PRIVATE SANITARY SEWER SYSTEM

TO SERVE LOT 1;
MOBILE MANOR SOUTH ADDITION

PROJECT NO: 895 PPS
INDEX CODE: 607861

As-BUILT PLANS: 03/23/2000

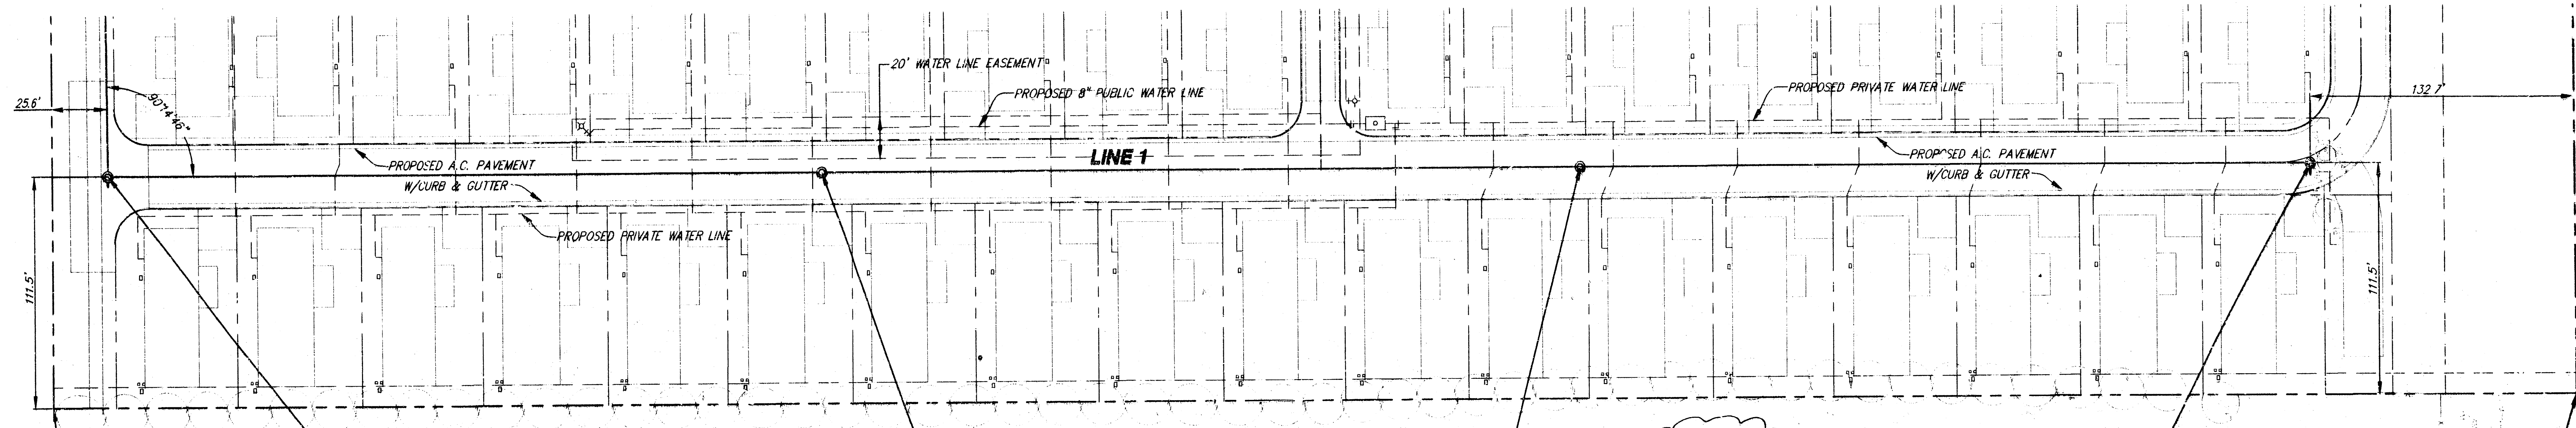
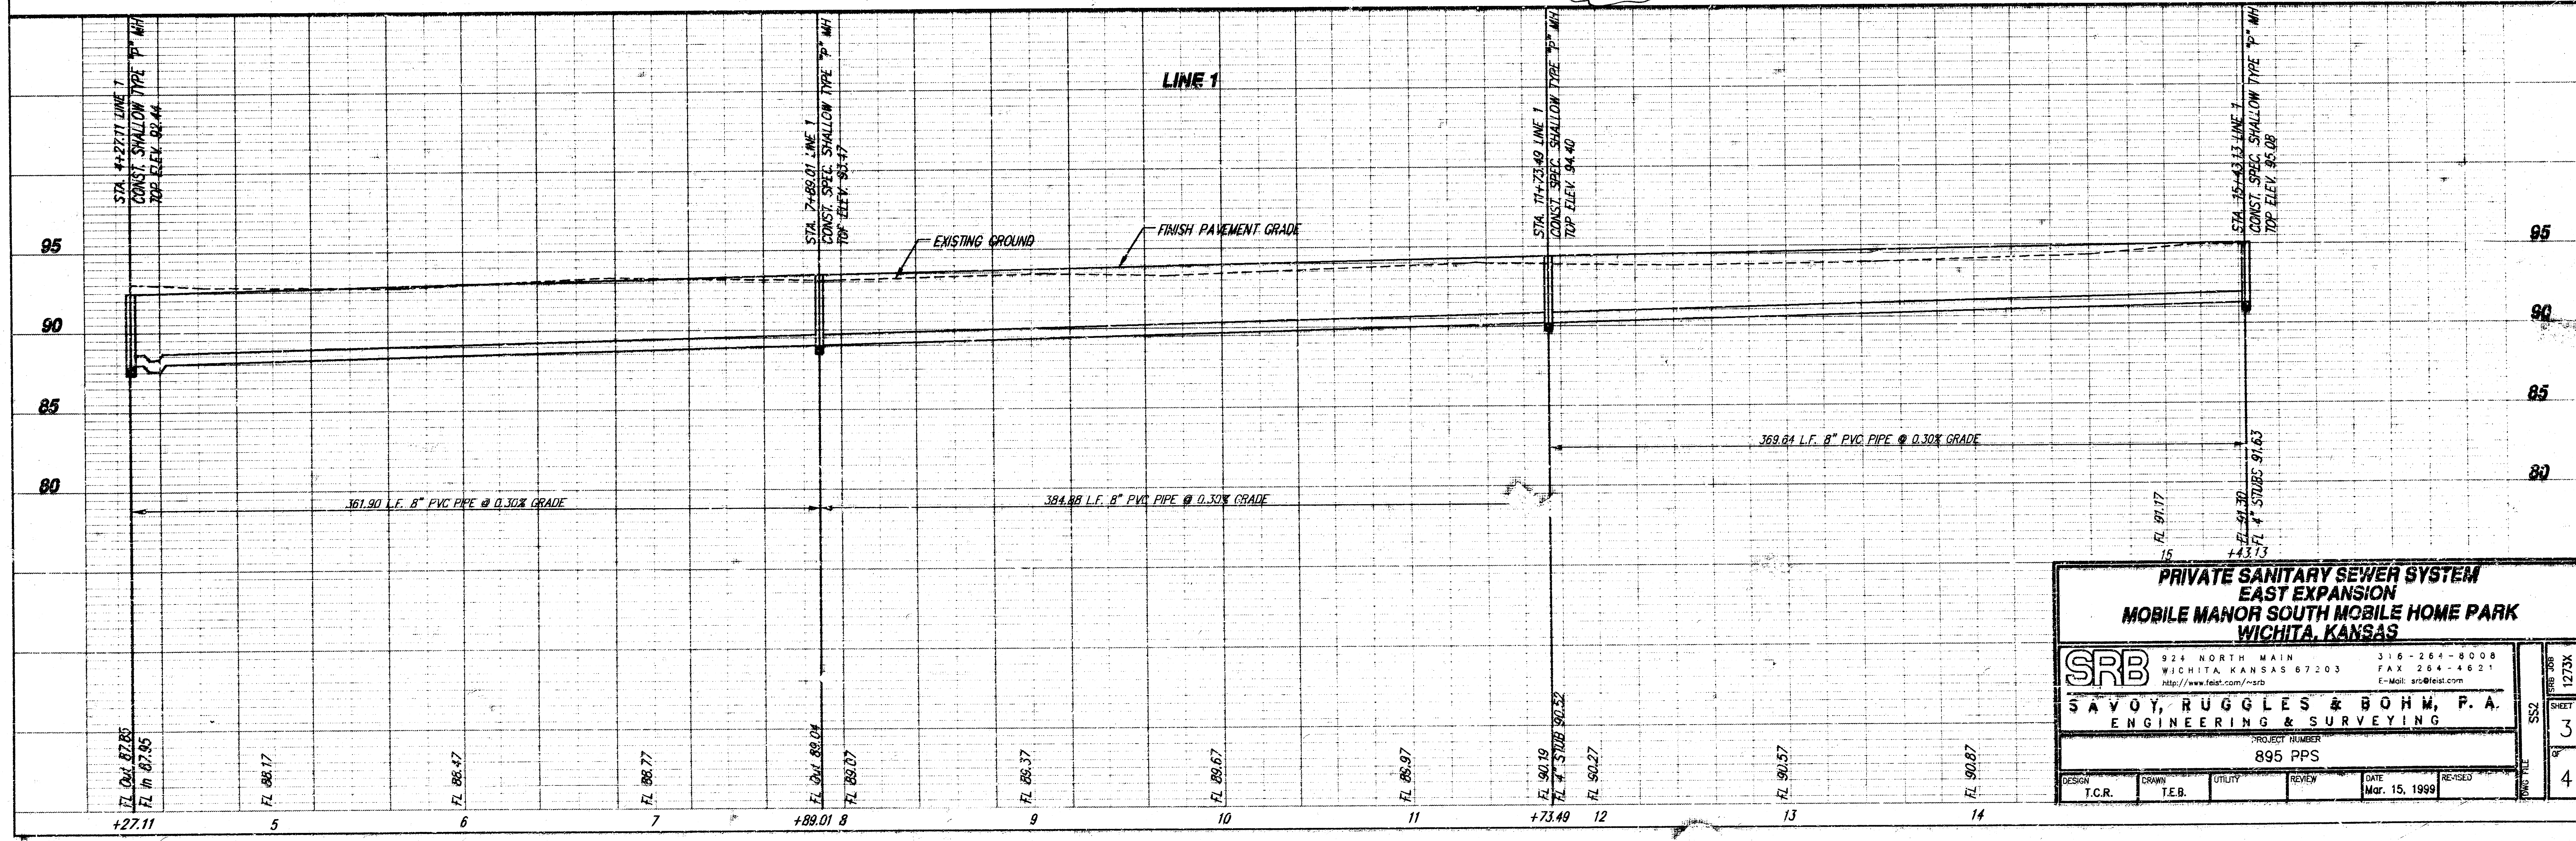
STA. 4+27.11 LINE 1
CONST. SHALLOW TYPE "P" MANHOLE
TOP ELEV. 92.44; 4" STUB ~~W/E~~ E
CONSTRUCTED TRAP PER
DETAIL, SHEET 2

This line built per
plans, with the addition
of the trap @ MH sta
4+27.11
